NU-10-X01 *Altresco 41A 1715 or 1816 SPS*

TRANSMISSION FACILITIES PROPOSED PLAN APPLICATION

1. Applicant Northeast Utilities Date April 5, 2010
2. Type of Facility Altresco 41A 1715 or 1816 SPS In-Service Date December 4, 2009
3. Transmission Line and/or Substations
 - a. From Altresco 41A Substation, Pittsfield, MA To Doreen 19A Substation, Pittsfield MA line #1715
and
From Altresco 41A Substation, Pittsfield, MA To Doreen 19A Substation, Pittsfield, MA line #1816

Figure 1: Transmission One-Line (Before Project)

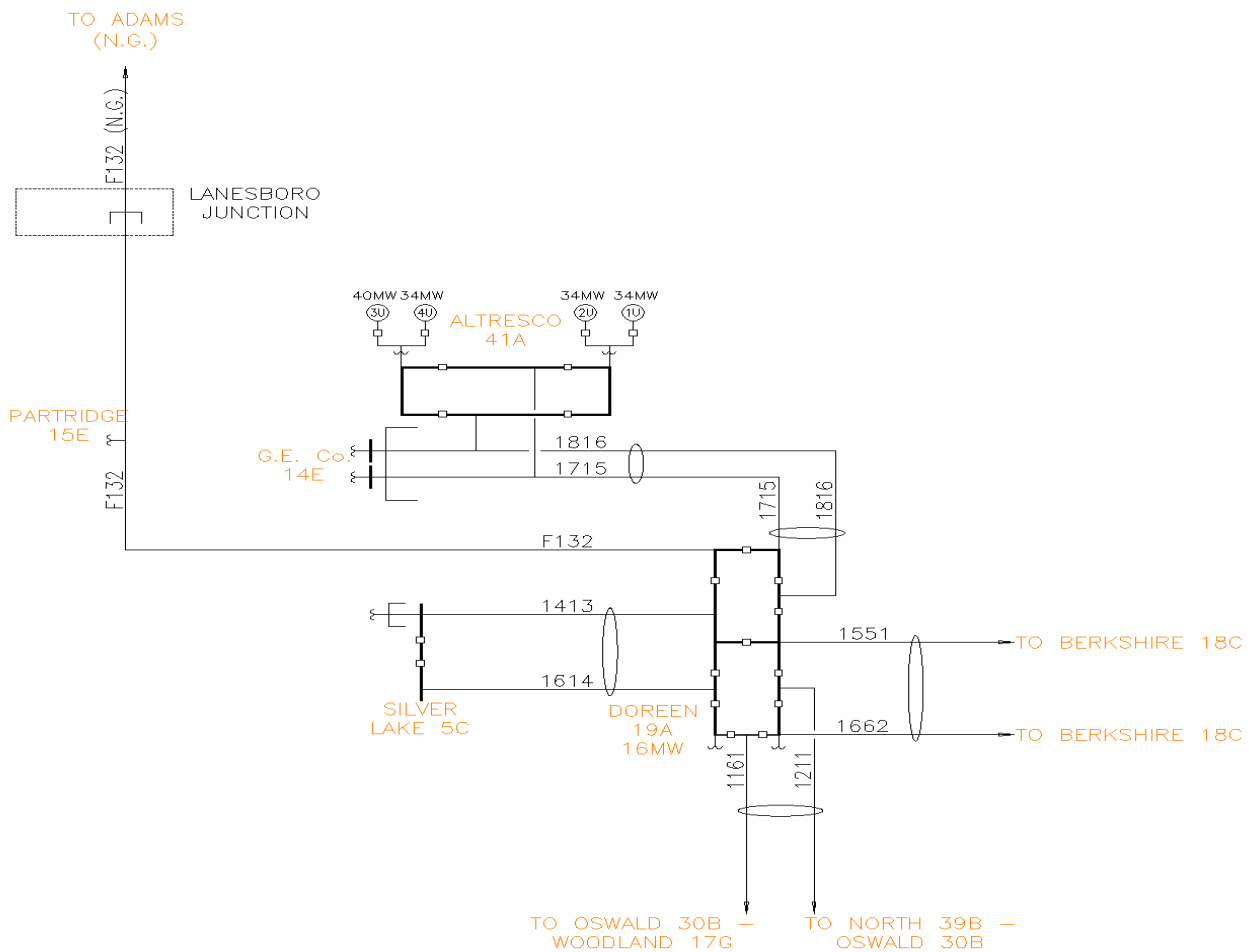
A type III Special Protection System (SPS) is in-service at Doreen 19A to detect line loads on the 1715 Line and the 1816 Line. The relays are set at 580 amperes summer and 580 amperes winter. If an overload condition continues for more than 25 seconds, the Overload Relays will send an Audio Tone Trip signal to Altresco 41A. At Altresco, the Audio Tone Receiver pick-up a timer that after 5 seconds will operate the 86TT/SPS Lockout that in turn will trip two generator breakers (1 gas turbine and 1 steam generator). At the same time, an alarm will be sent to CONVEX informing CONVEX the Overload Relay has operated. The purpose of this SPS is to protect the 1715 and 1816 lines from overload above 580 amperes.

The purpose of this project is to modify the setting of the relay to protect the lines from being overloaded during the summer season. The set points of the relays will be changed to 475 amps in order to protect the circuits during the entire year. The summer normal, LTE and STE ratings of both the 1715 and 1816 line are 485 A.
